Western & University

Design Review Board Recommendation Meeting

MACK URBAN & ANKROM MOISAN ARCHITECTS, INC.
DPD #3014451 / **19 AUGUST 2014**

Proposed massing with View Corridor setback only better meets Design Guidelines

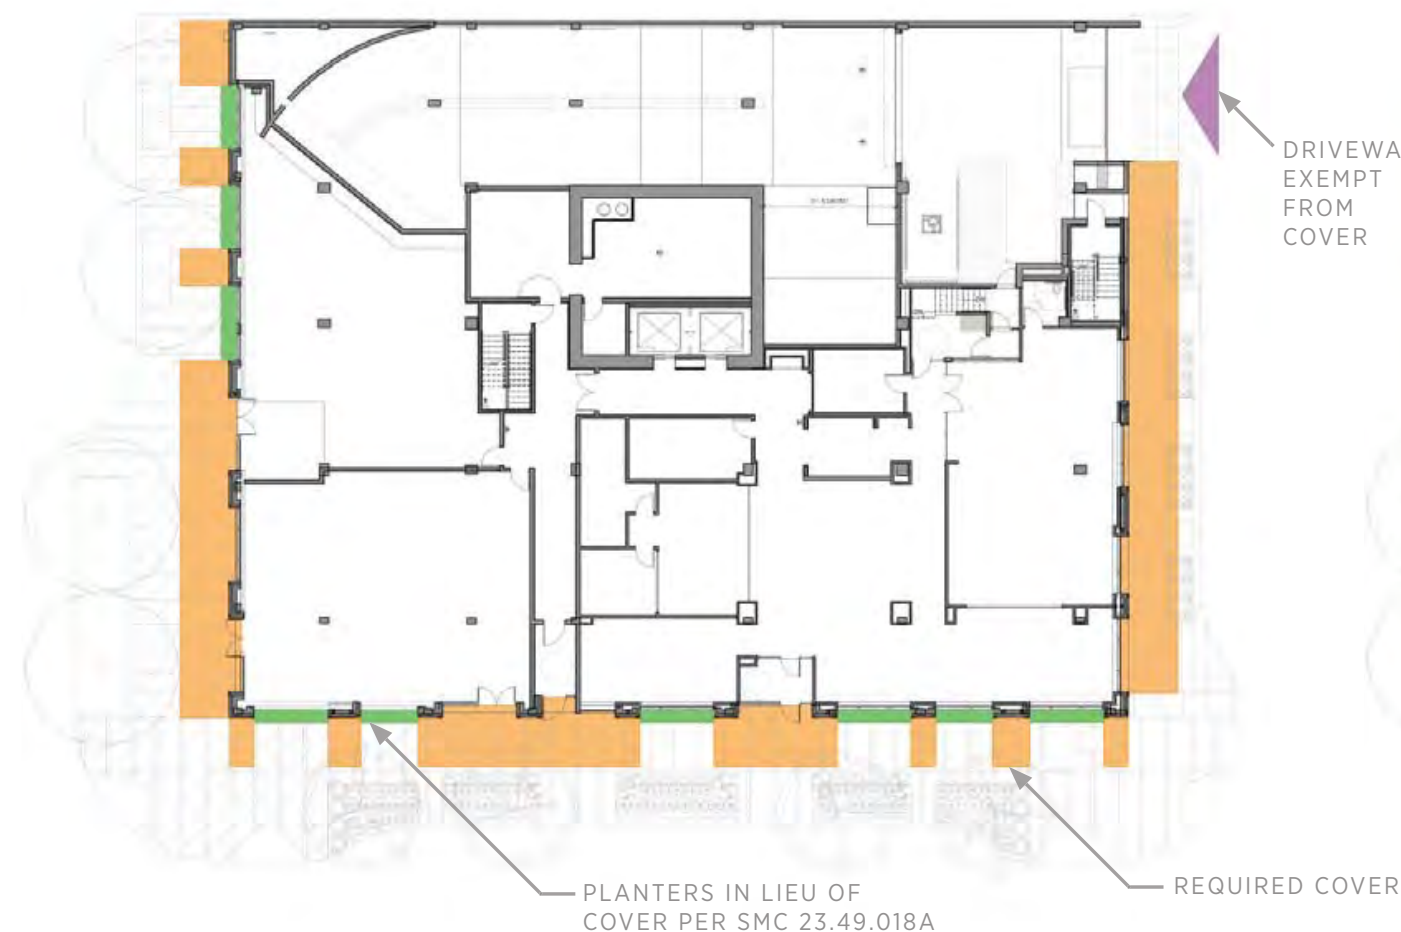
“When a lot in a DMC zone is located on a designated green street, a continuous upper-level setback of fifteen feet shall be provided on the street frontage abutting the green street at a height of 45 feet.”

The applicant proposes to setback the structure's upper level to align with existing developments along University St., according to the view corridor regulations at a height of 75 feet. The design team does not advise a double setback and asserts a setback at 45 feet better meets the design guidelines.

The property has twin upper level setback requirements based on the green street and view corridor criteria. Allowing the project to abide by the view corridor standards would better align with existing developments along University St and maintain the urban street wall. DPD staff has indicated that the designation of a green street at this location is redundant
